Access Compliance Report Public Rights-of-Way (Curb Ramps)

Intersection ID: 48408 Main Street: ERNIE_DR Cross Street: BRYN_ATHYN_CT Location: SE

ADA ID: 9C278CB6658D Ramp Type: PerpDiag Initial Pass/Fail: Fail Overall Compliance: No Severity Score: 10

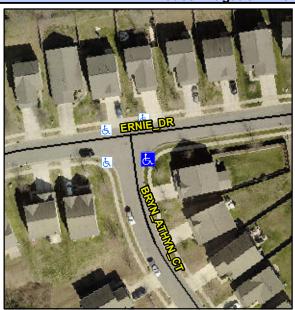
Not Found, R304.5.1, R304.5.3

Fleid Measurements/Component Compilance						
	Comp	Compliance Description		Comp	liance Description	Data
	N/A	Ramp Length (in)	49.0	Yes	Ramp Slope (%)	5.3
	No	Ramp Width (in)	47.5	No	Ramp XSlope (%)	4.0
	N/A	Flare Type LT	N/A	N/A	Flare Type RT	N/A
	N/A	Flare Slope LT (%)	N/A	N/A	Flare Slope RT (%)	N/A
	N/A	Flare Traversable LT?	N/A	N/A	Flare Traversable RT?	N/A
	N/A	Landing Length (in)	N/A	N/A	DWS Provided?	N/A
	N/A	Landing Width (in)	N/A	N/A	DWS Contrast?	N/A
	N/A	Landing Slope (%)	N/A	N/A	DWS Length (in)	N/A
	N/A	Landing X Slope (%)	N/A	N/A	DWS Full Width?	N/A
	N/A	Landing Curb? (Y/N)	N/A	N/A	DWS Offset (in)	N/A
	N/A	Shared Landing?	N/A			
	N/A	Gutter Ponding?	N/A	N/A	Gutter Slope (%)	N/A
	N/A	Gutter Lip Ht (in)	1.0	N/A	Gutter X Slope (%)	N/A
	N/A	Painted X Walk1?	No	N/A	Painted X Walk2?	No
		X Walk 1 Direction	To N		X Walk 2 Direction	To W
	N/A	X Walk 1 Width (in)	N/A	N/A	X Walk 2 Width (in)	N/A
		X Walk 1 Slope (%)	1.4		X Walk 2 Slope (%)	1.1

Remove & Replace Curb Ramp With Two New Directional Ramps or Equivalent.
